Subject: Rice Solar Energy Project (09-AFC-10)
Response to CEC Workshop Queries 4, 6-8, and 11

Responses to CEC Staff Workshop Queries 4, 6-8 and 11

Rice Solar Energy Project

(09-AFC-10)

**FIGURE WSQ4-1
OPERATIONS PHASE
PERMANENT FENCELINE**
Rice Solar Energy Project
Riverside County, California

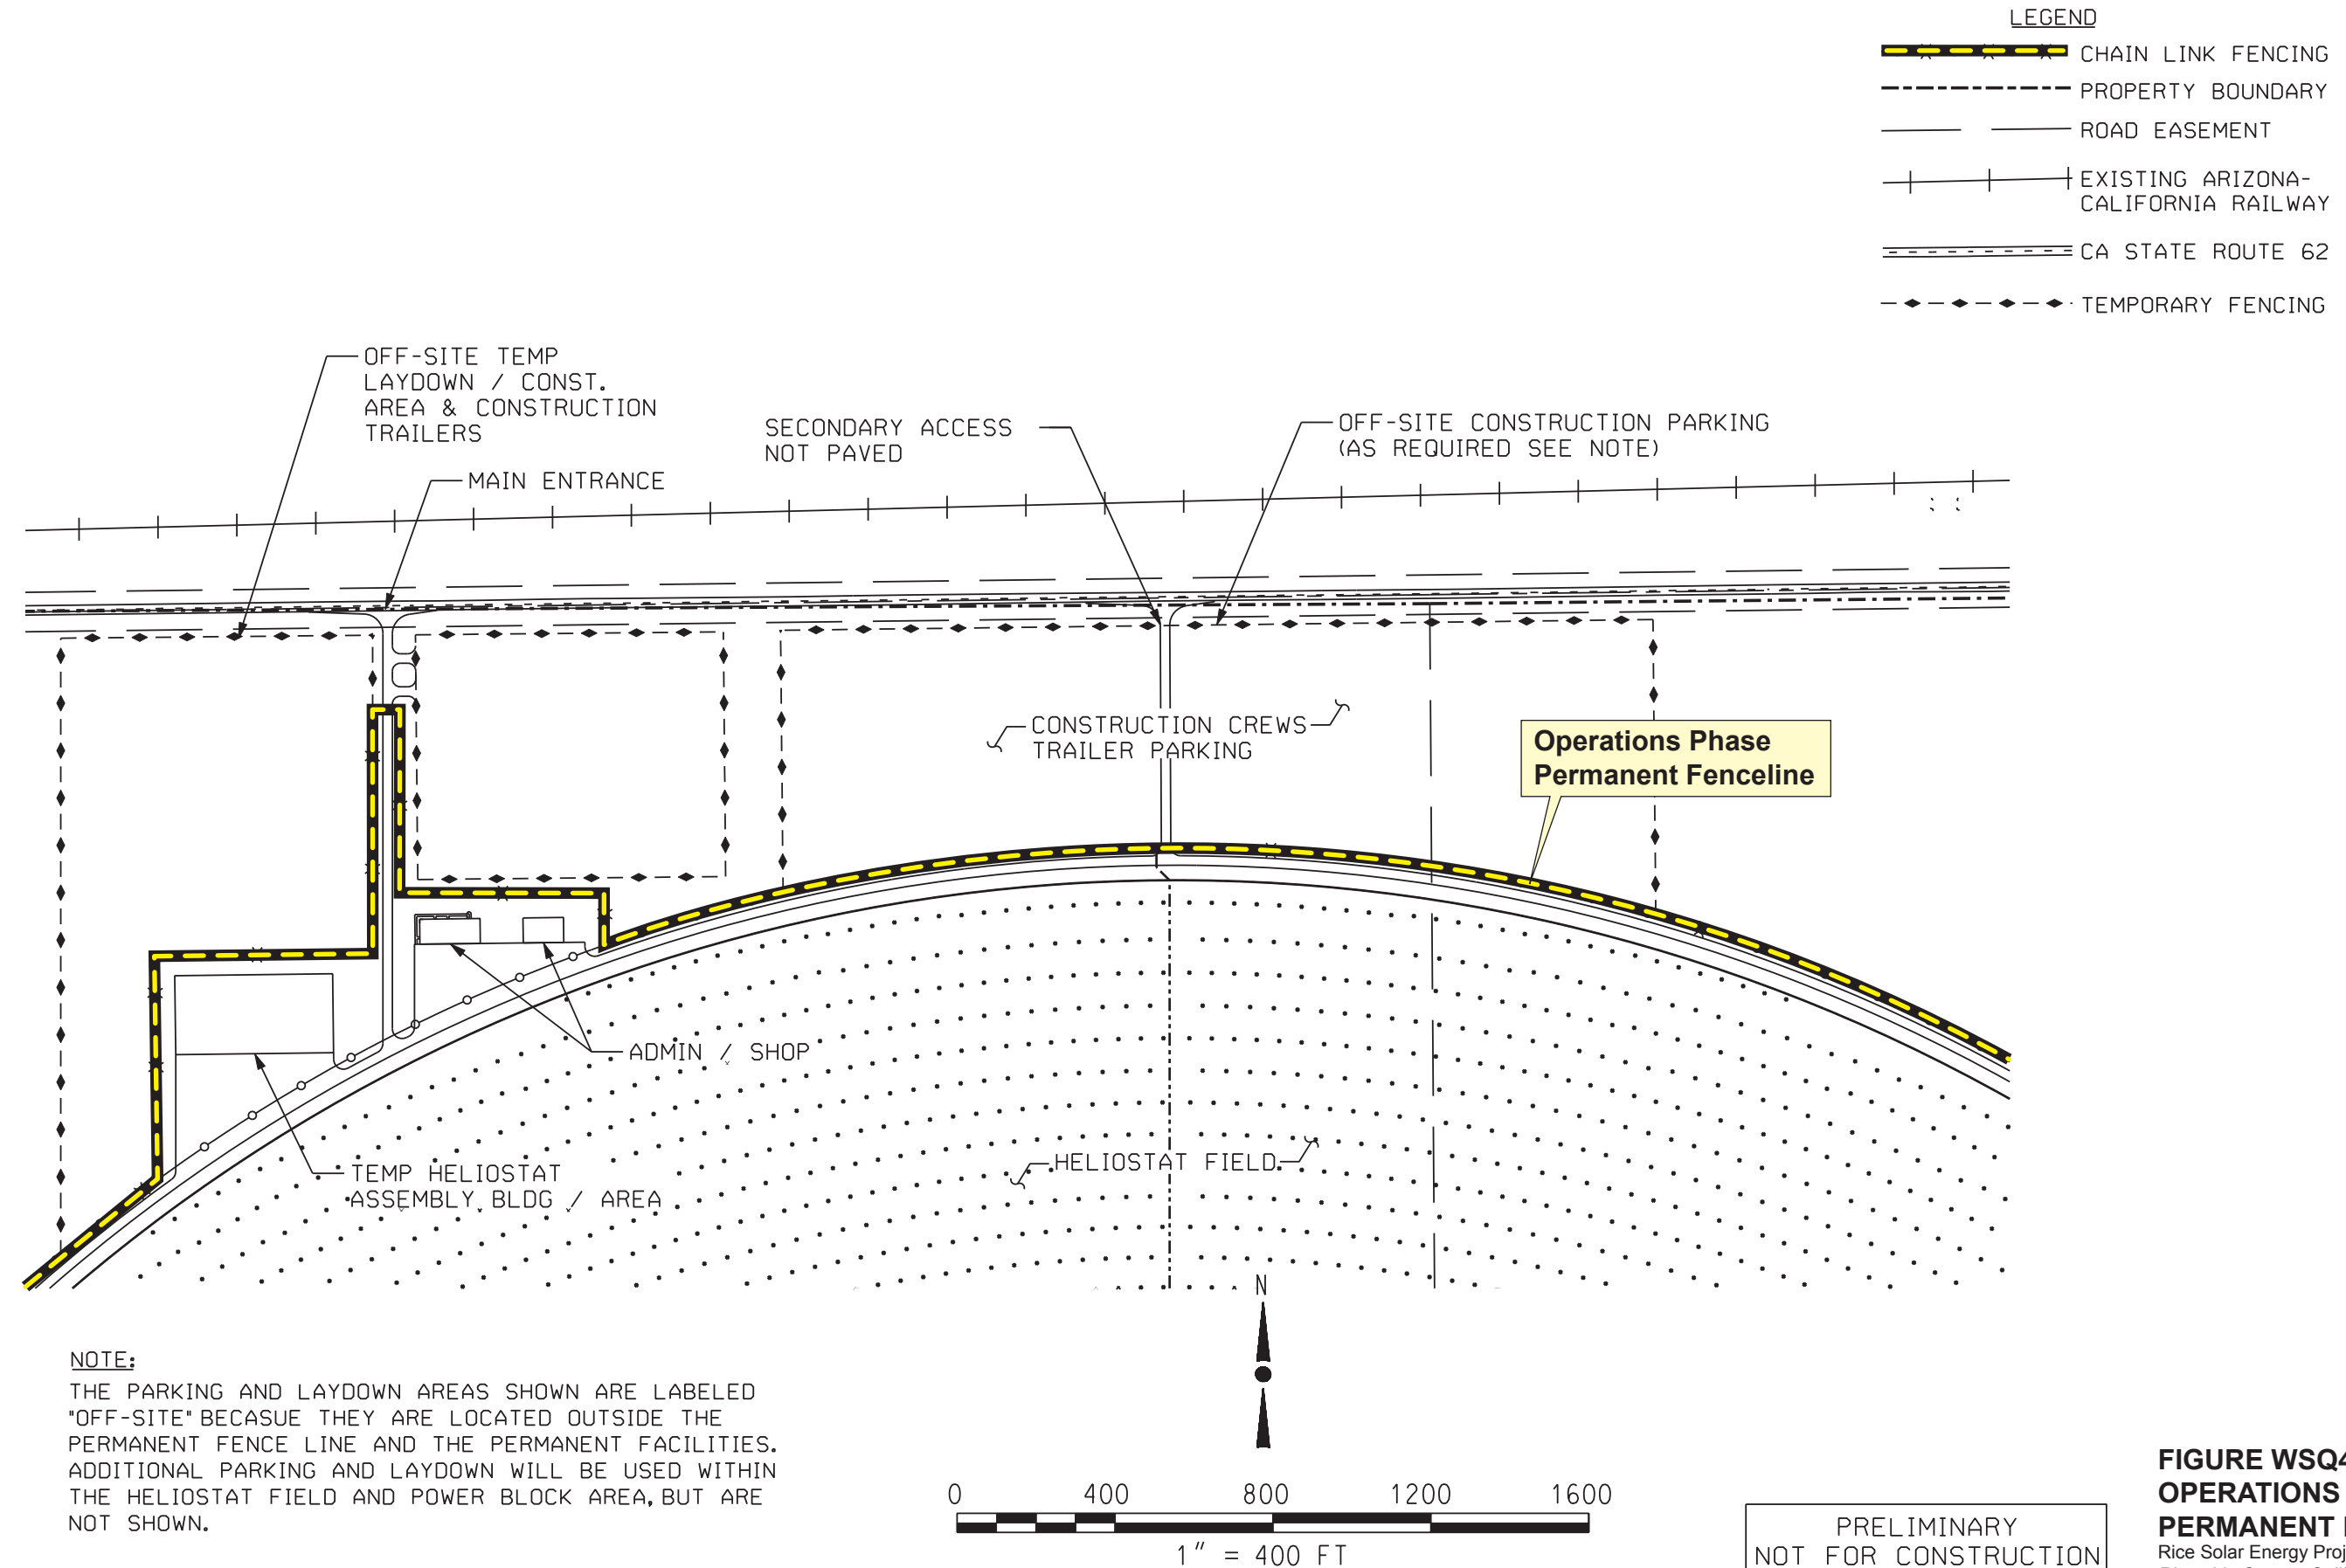
WSQ 4 Please provide an illustration that shows the fenced area during the operations phase of the project, at the north end of the heliostat field (as opposed to the fenced area during construction).

Response: During construction, the fenced area at the north end of the heliostat field will include the administration and shop building, heliostat assembly building, worker parking, worker residence (trailer park), and construction laydown areas. Once construction has been completed, this fenced area will shrink by approximately 94 acres. The total fenced area including the heliostat field will be reduced from 1,504 to 1,410 acres. The fenced area during operations will contain only a fenced access roadway connecting the heliostat field with State Route 62, the administration/shop building, and the heliostat assembly building. The construction laydown and worker parking areas will no longer be used and will be outside of the permanent fence. This is illustrated in Figure WSQ4-1.
